**APPLICATION FOR PERMISSION  
UNDER SECTION 16 OF  
THE TOWN PLANNING ORDINANCE  
(CAP.131)**

(a) Proposed use(s)/development 擬議用途/發展	Temporary Warehouse for Storage of Exhibition Materials for a Period of 3 Years  (Please illustrate the details of the proposal on a layout plan) (請用平面圖說明擬議詳情)

# **Proposed Temporary Warehouse for Storage of Exhibition Materials for a Period of 3 Years**

**Lots 597 RP (Part), 599 RP, 601 RP, 602 (Part), 637 RP (Part), 638 RP, 639 RP, 648 RP, 649 RP, 650, 651, 652 (Part) & 653 RP in D.D. 124 and Adjoining Government Land, Ha Tsuen, Yuen Long, N.T.**

Proposed Drainage Plan

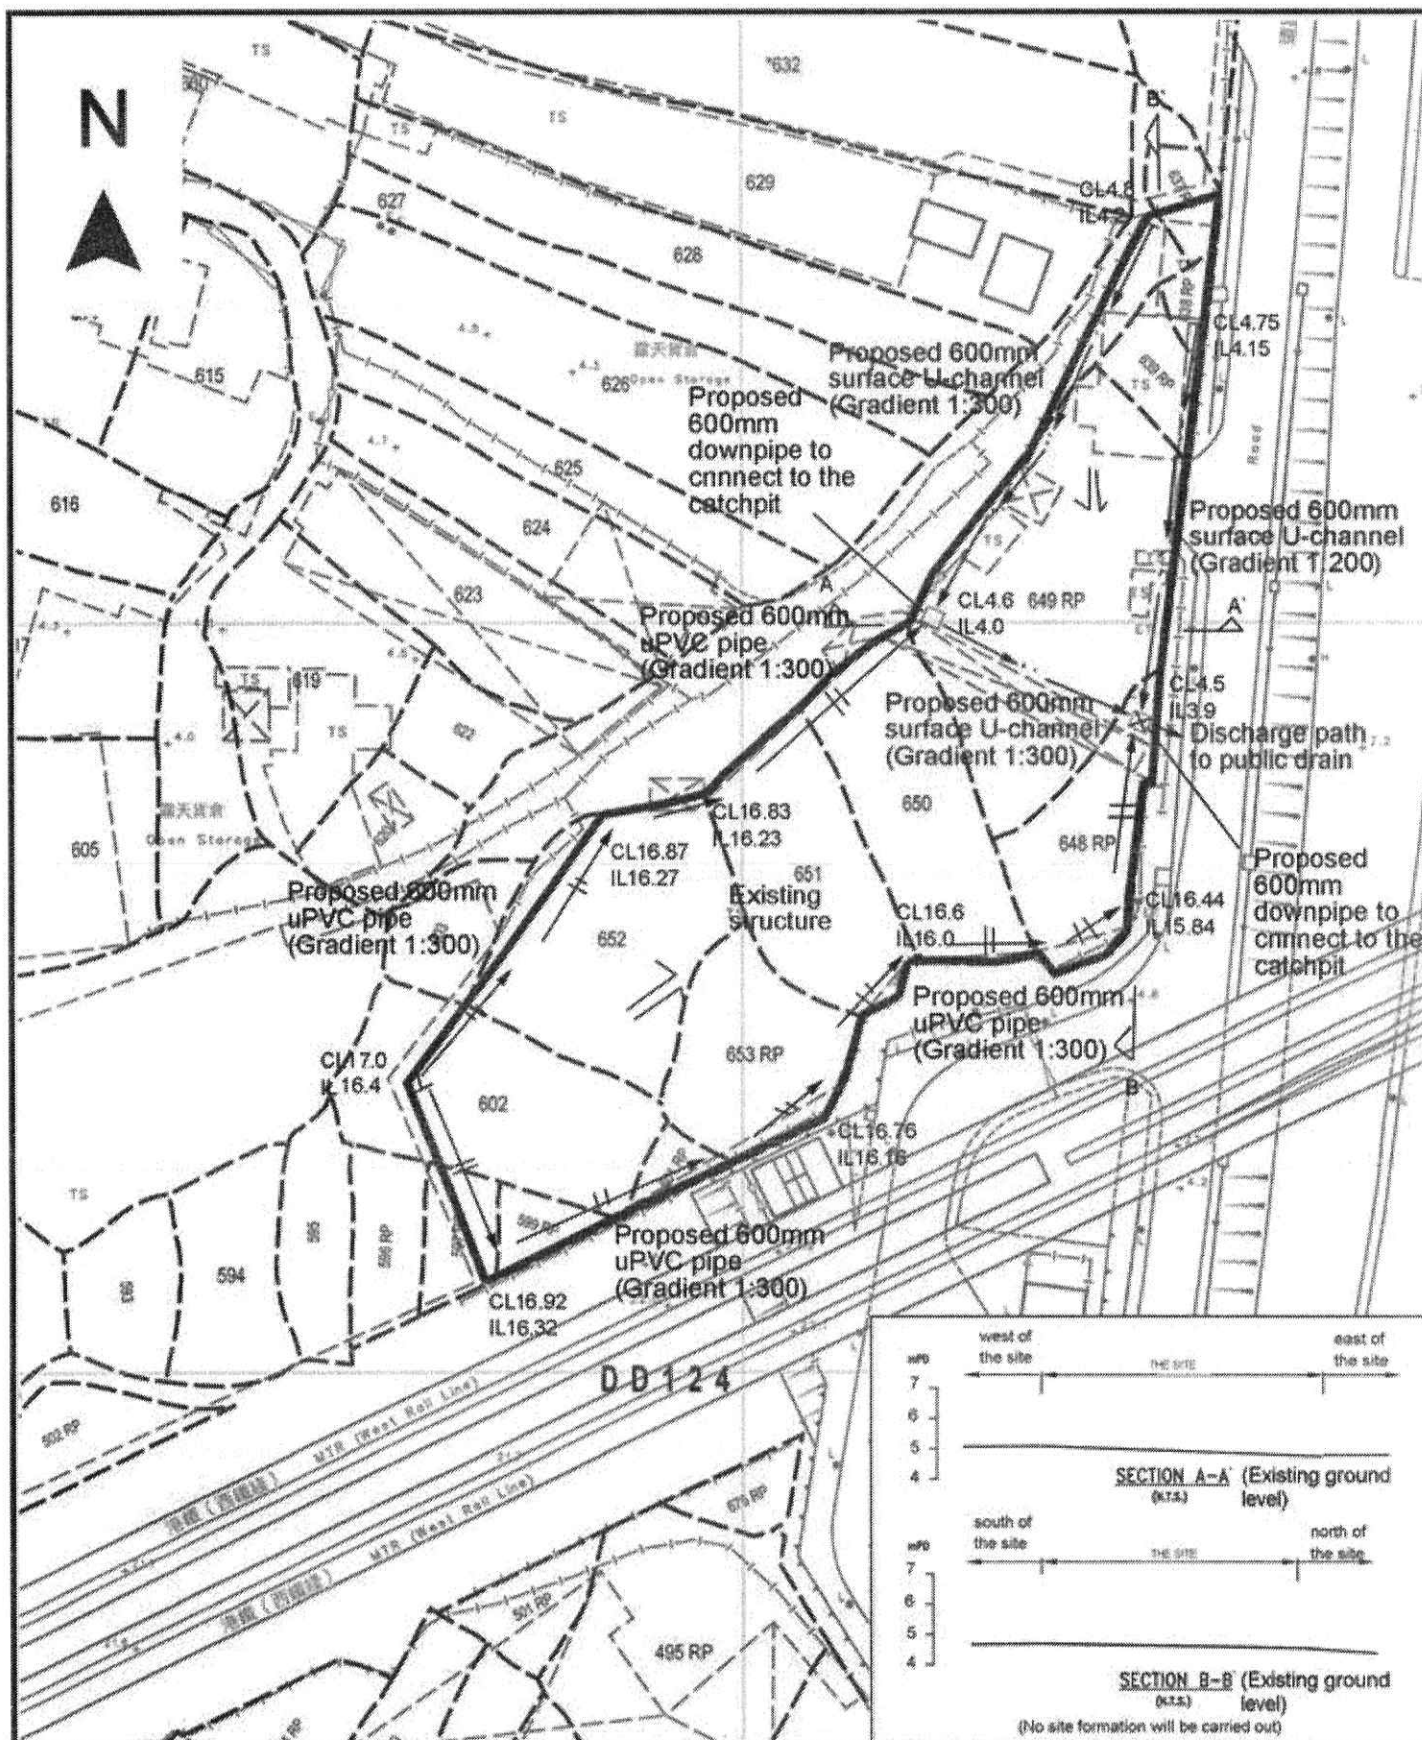
- (h) to note the comments of the Chief Engineer/Mainland North, Drainage Services Department that the required implementation of the accepted drainage proposal should include coloured photos showing the current condition of the drainage facilities and a layout plan indicating the locations of the photos taken. The submitted photos should cover all internal surface channels, catch pits, sand traps, manholes, terminal catch pits/manholes and the downstream discharge path as indicated on the submitted drainage proposal;

- 1.2.1 Subject to the above calculations, it is determined that 600mm surface U-channel which is made of concrete along the site periphery is adequate to intercept storm water passing through and generated at the application site. **(Figure 4)**

- 1.2.2 The collected surface runoff will be conveyed to the public drain to the east of the site through the proposed 600mm surface U-channel outside the site boundary.

DRAWING TITLE :  
**F.S. Notes, Legend,  
Fire Service Installation  
Layout Plan**

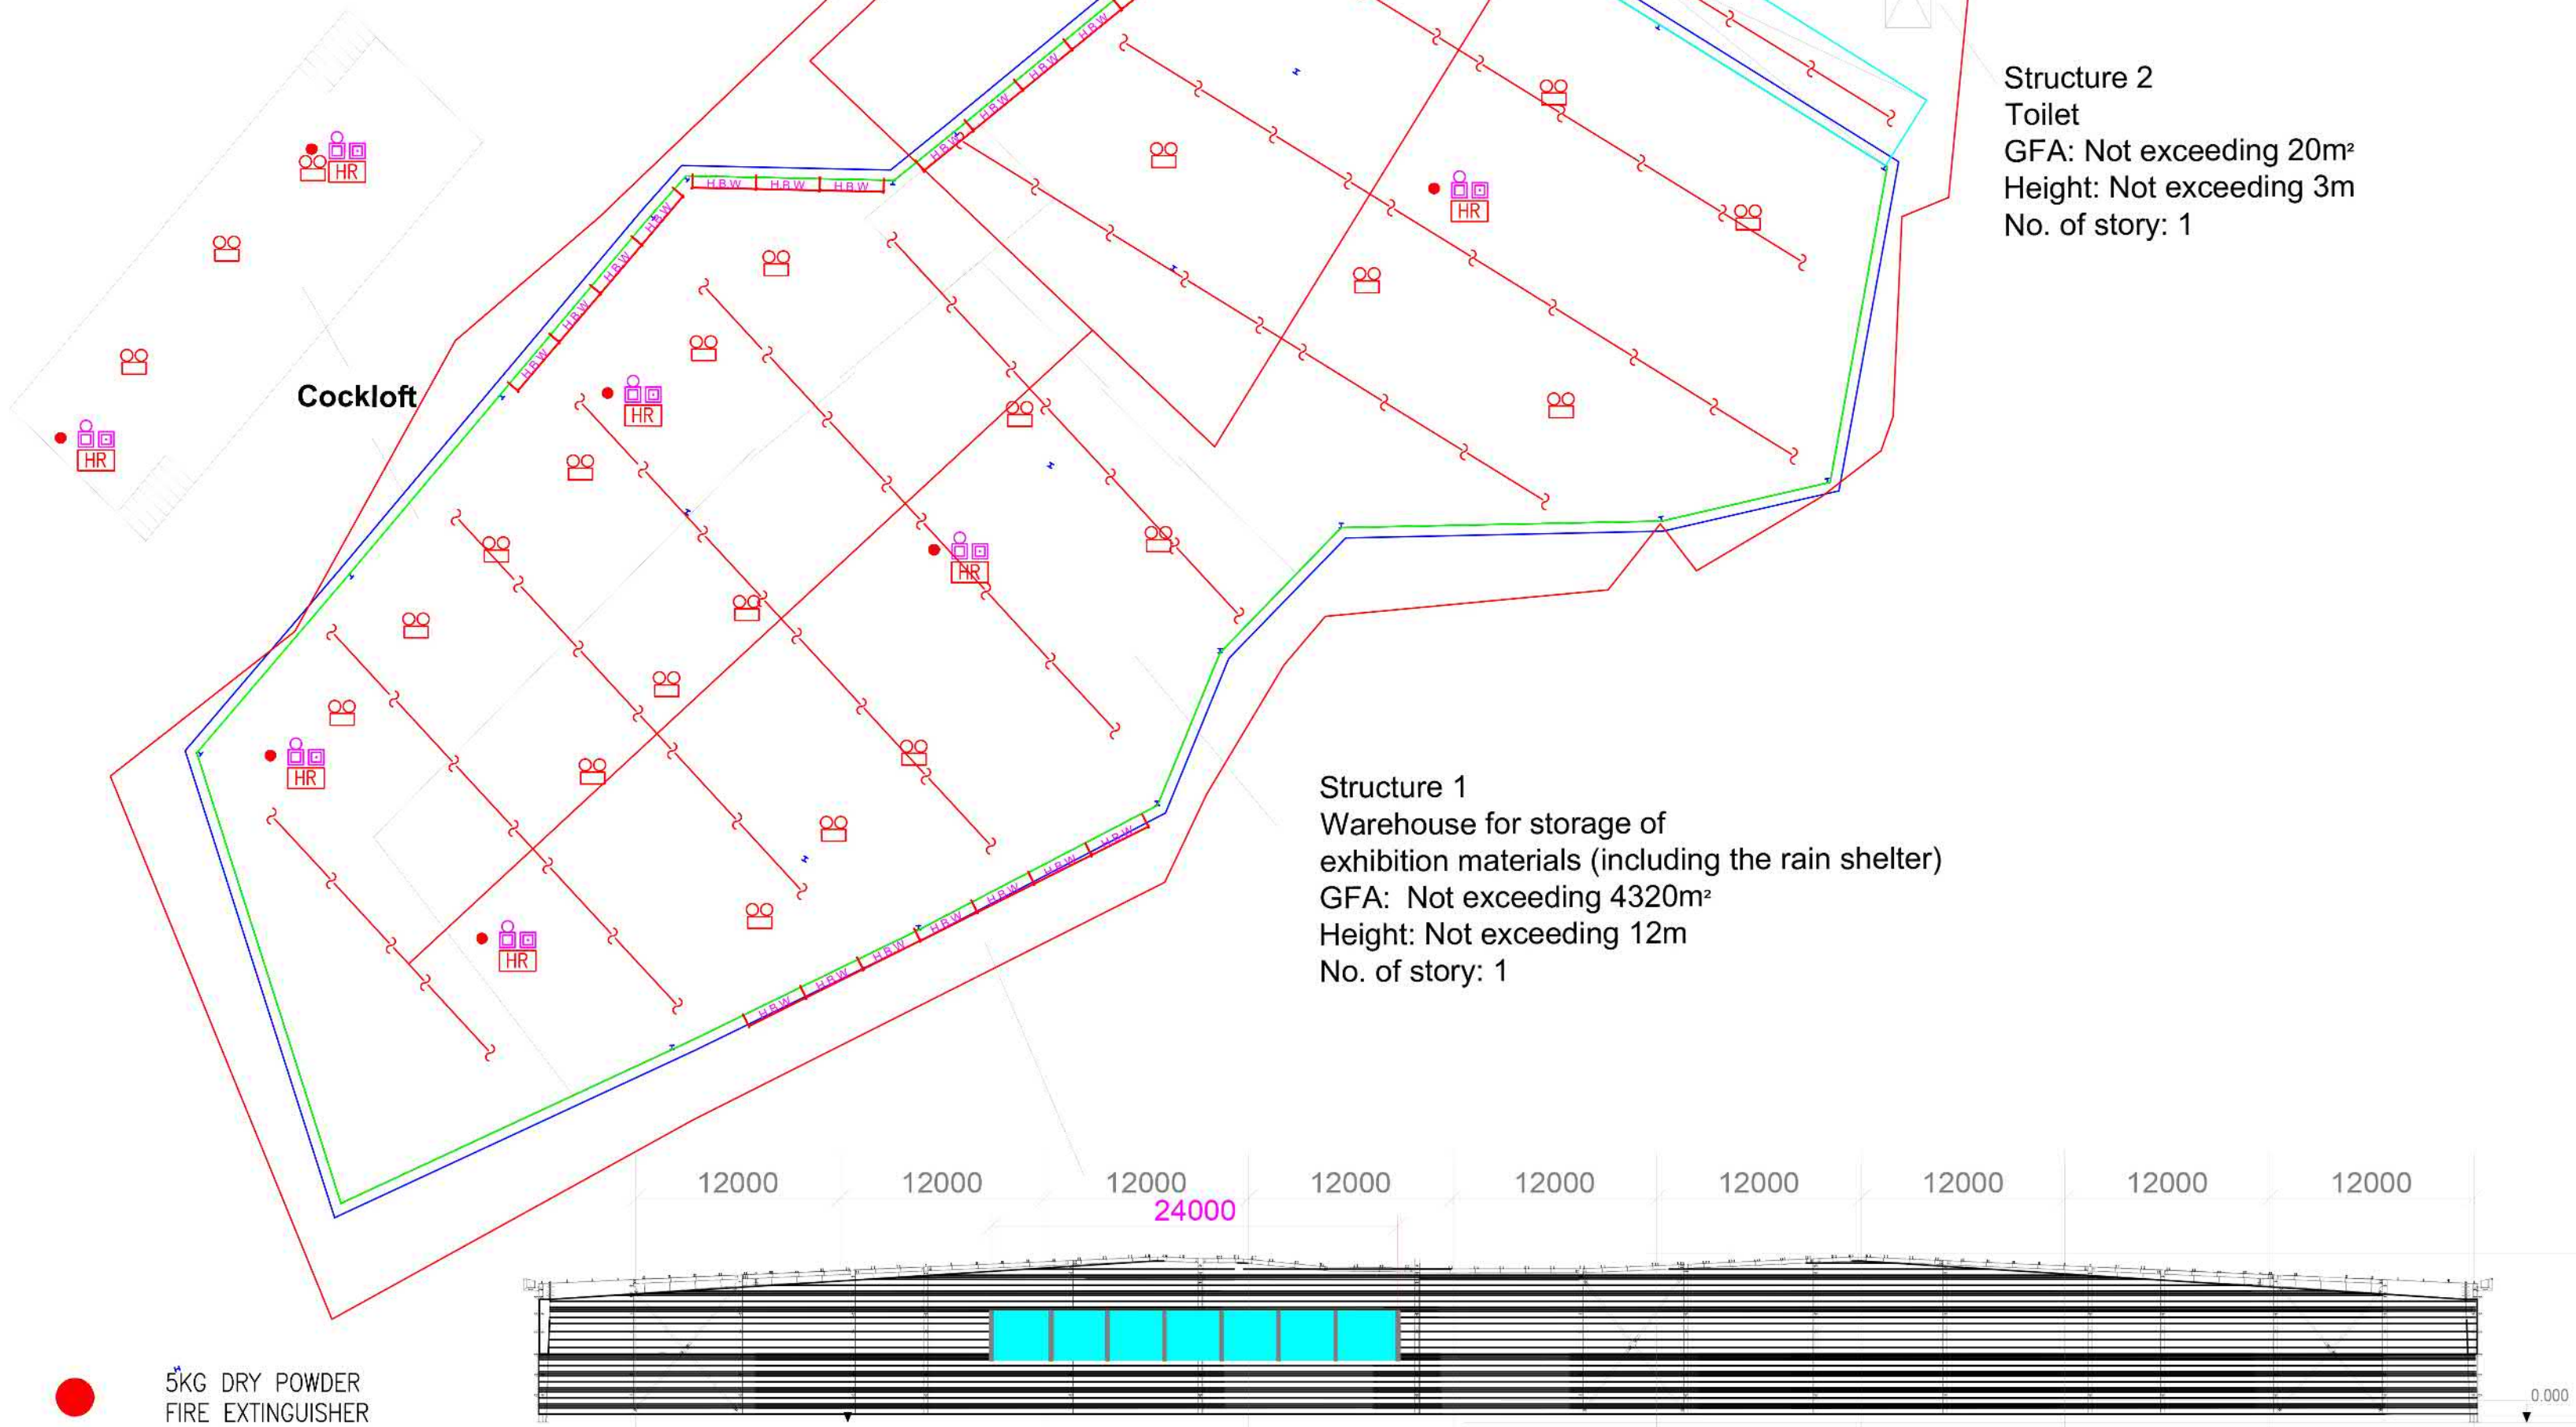
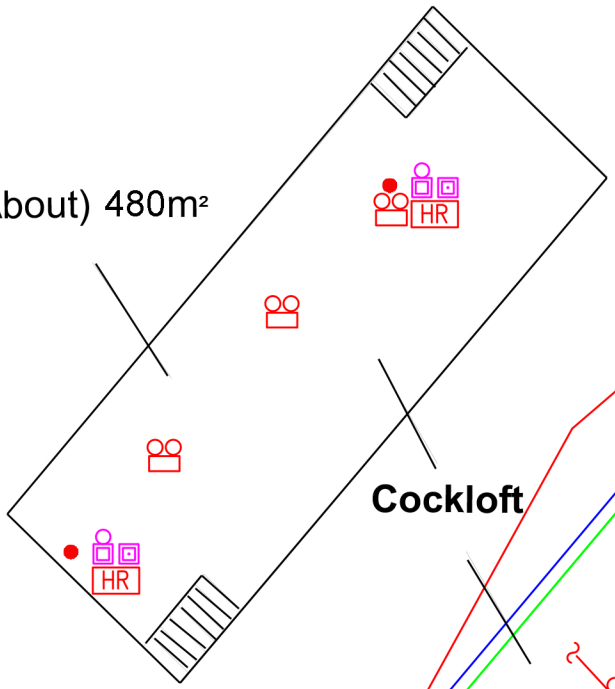
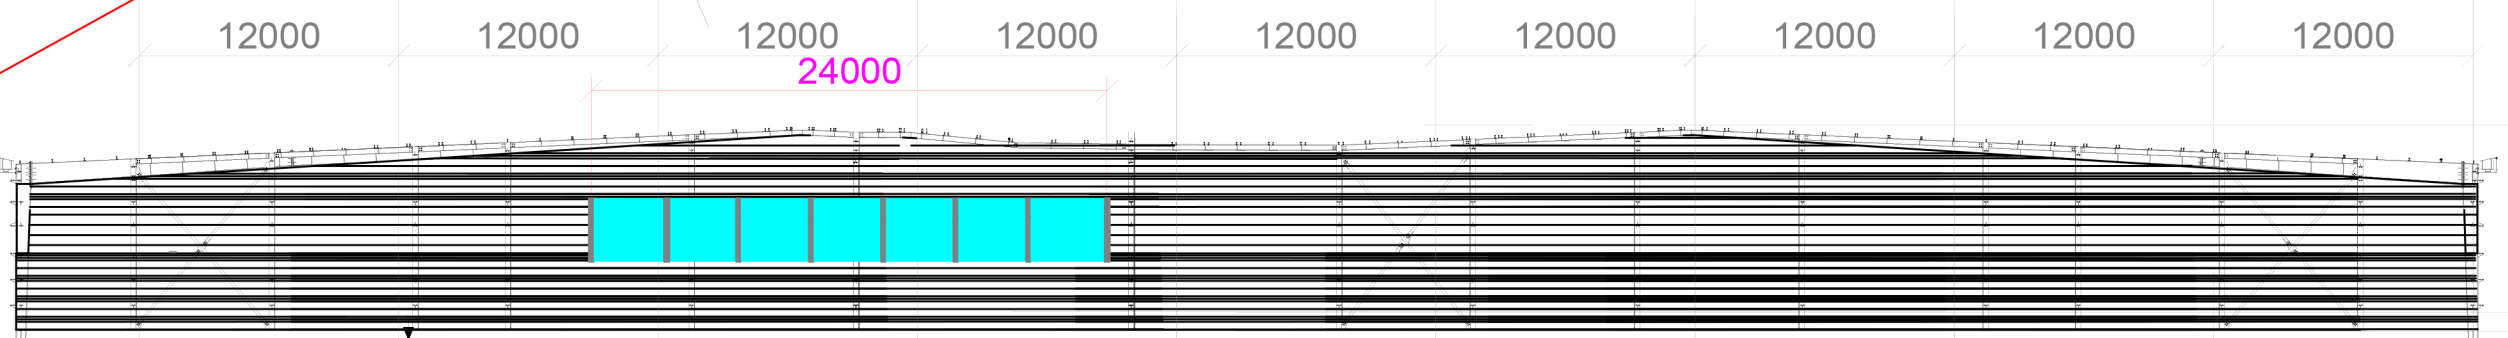
This letter intends to supersede our letter dated 16.5.2023. In response to the comments of the Director of Fire Services, we are glad to submit the updated FSI proposal for the consideration of the Director of Fire Services (D of FS).

Our latest proposal is to provide an additional cockloft within the Structure 1 (i.e. warehouse) and the GFA of structure 1 has been increased as shown in the proposed layout plan from 4,320m<sup>2</sup> to 4,800m<sup>2</sup>. Please see the updated application form for your further processing of the captioned application.

Cockloft  
Floor Area (About) 480m<sup>2</sup>
